**H o u m a C i v i c C e n t e r C h i l l e r
R e p l a c e m e n t**

A d d e n d u m # 1

Today's Date: *9/21/22*

M3.0

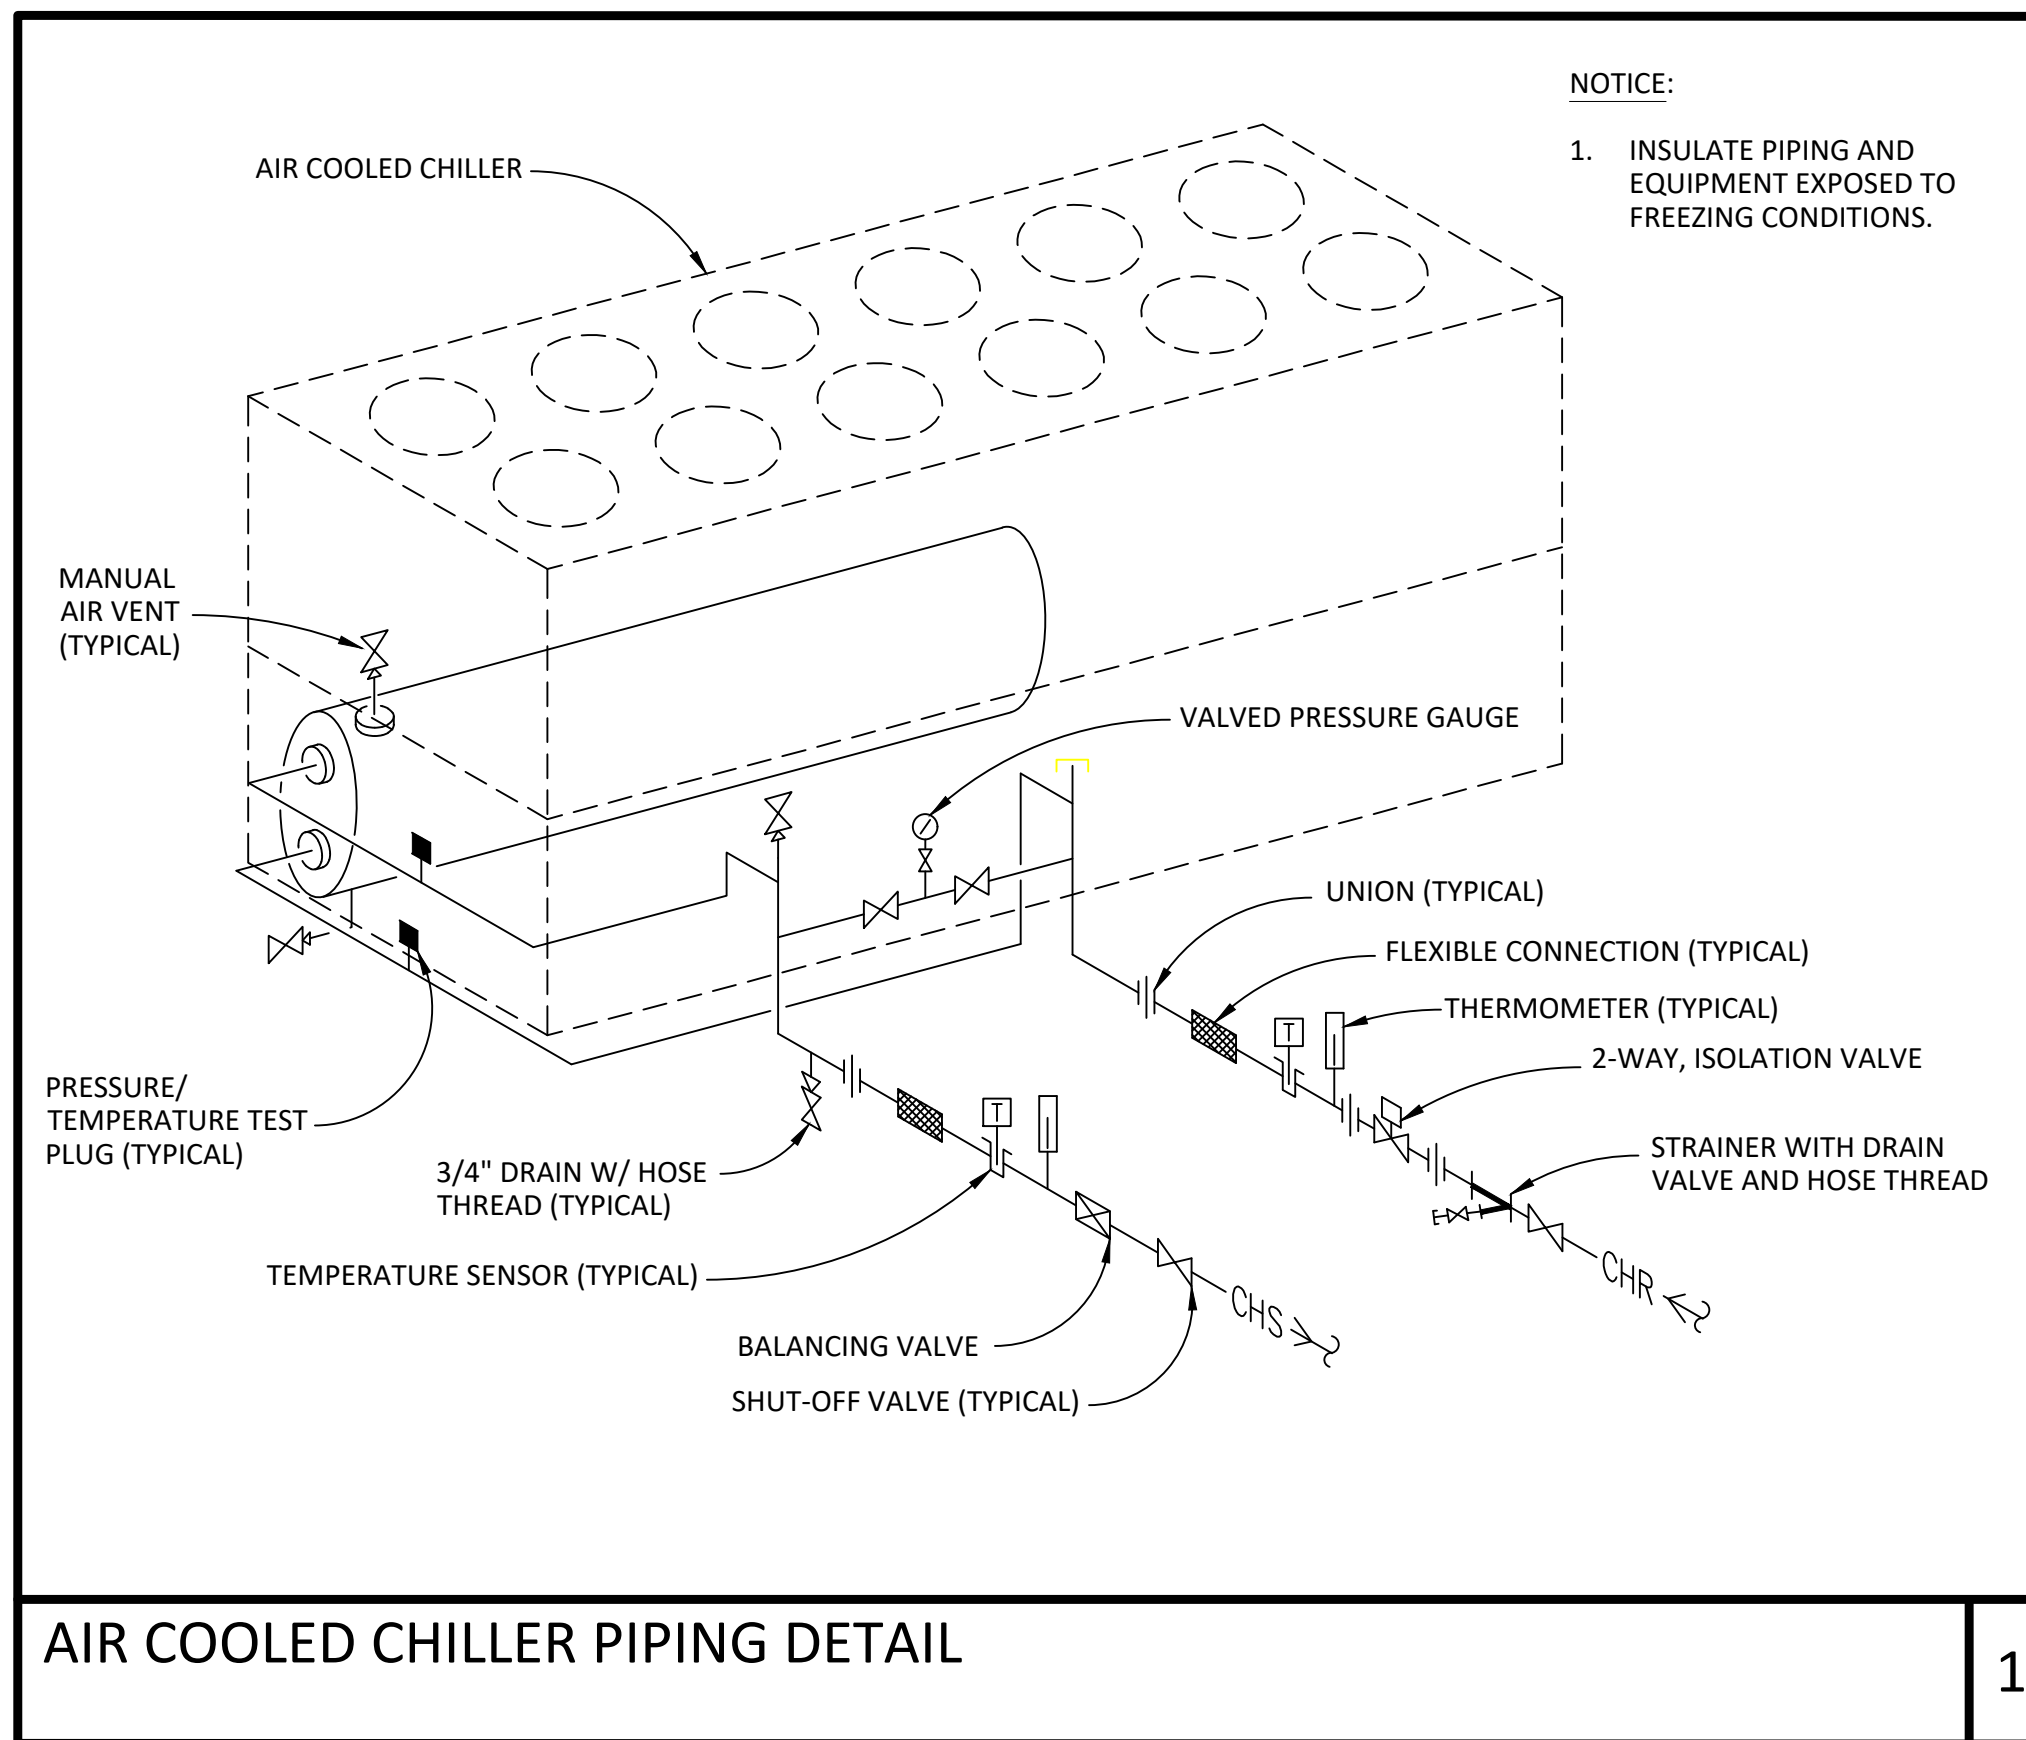
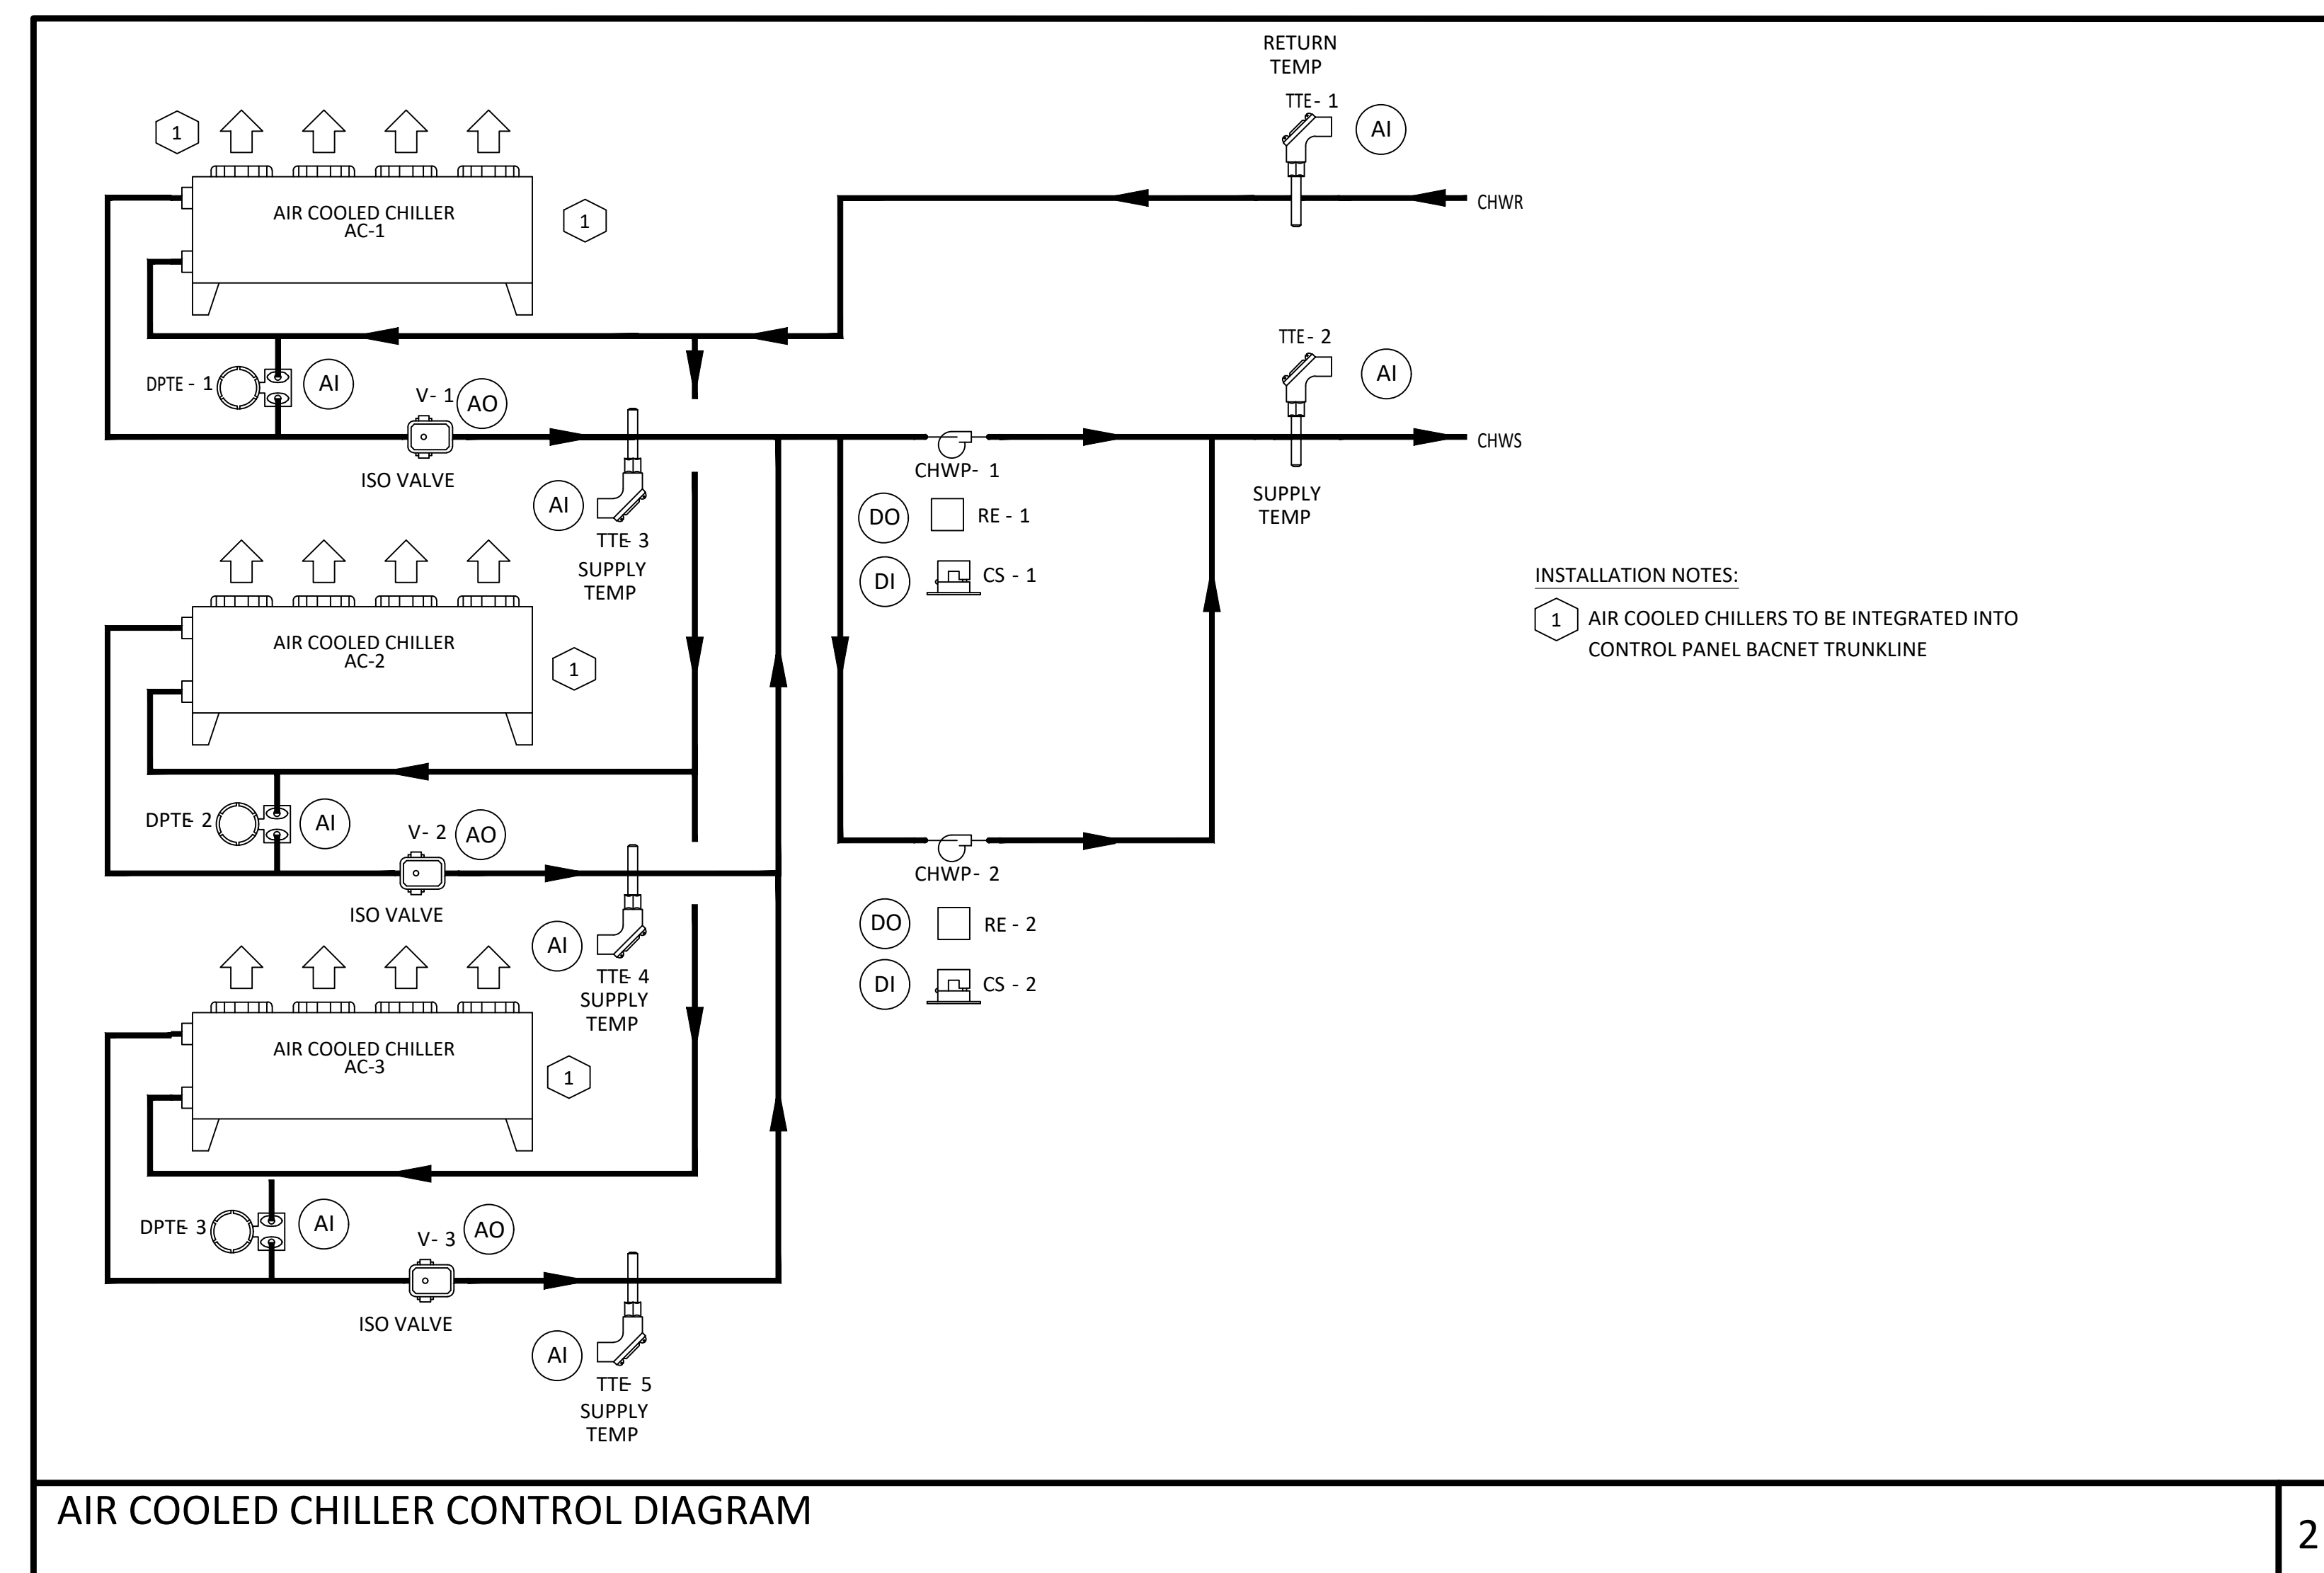
Clarifications	<ul style="list-style-type: none">• Attachment A and B has been included in the Bid Documents
Questions	N/A

NO.	REVISION #1 DESCRIPTION	DATE
1		2022.09.20
